Project: Barracks House

Title: Existing Side Elevations

Drawing NO: 1220

SOUTH FACING GABLE ELEVATION

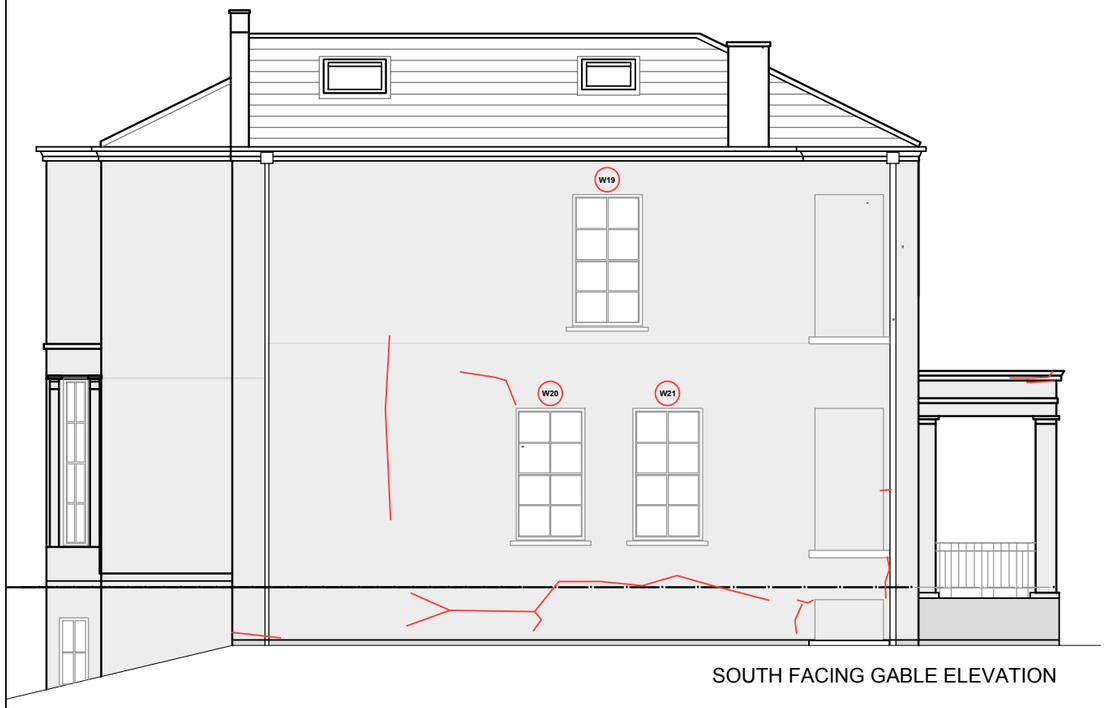
- Vegetation growth through cracks in the render poses various challenges & implication for structural integrity and aesthetics. This assessment focuses on the impacts of such growth, specifically addressing vegetation emerging from cracks in the render and around window frames.

- NY LEAVED TOADFLAX (or similar)
Can be seen growing through various area of the facade, through cracks in the render & mortar joints. This should be carefully removed, being mindful of potential damage.

NORTH FACING GABLE ELEVATION

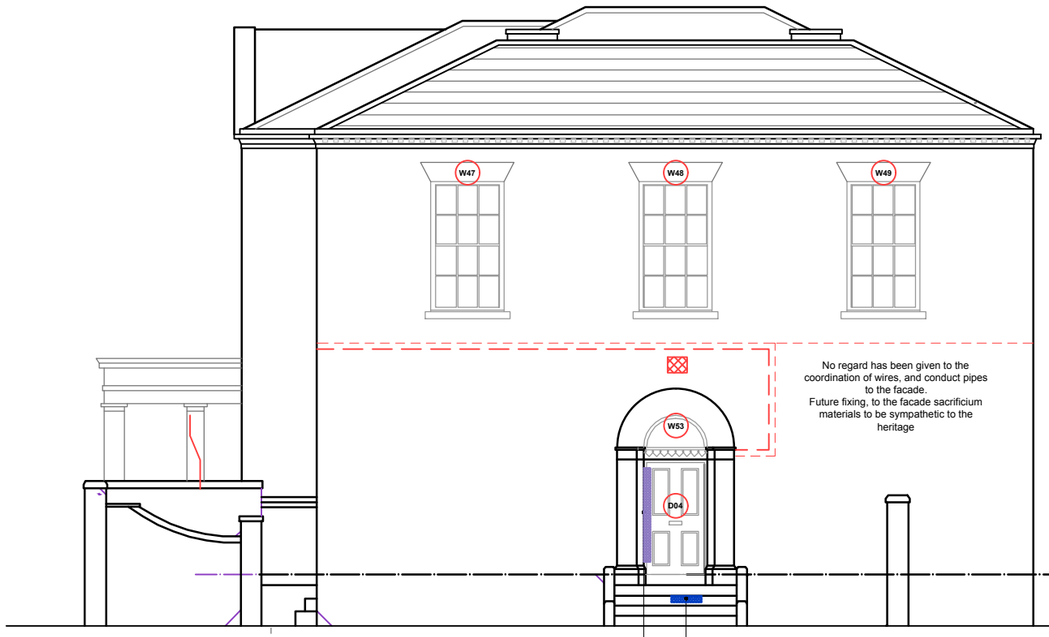
- To the underlying structure. If plant is seen to be established, consider using a systemic herbicide to kill it before removal. Repair any damage caused by the vegetation, including cracks in the render (Please refer to window schedule).

- All hanging wires should be fixed neatily to the facade by fixing to sacrificium materials such as mortar joints.
Example can be seen on north facade elevation.

- Ensure any fixing points such as screws are fixed into mortar join, rather than failing brick.

- Existing penetrations for boiler flue to be revisited and made good by removing & re-installing.
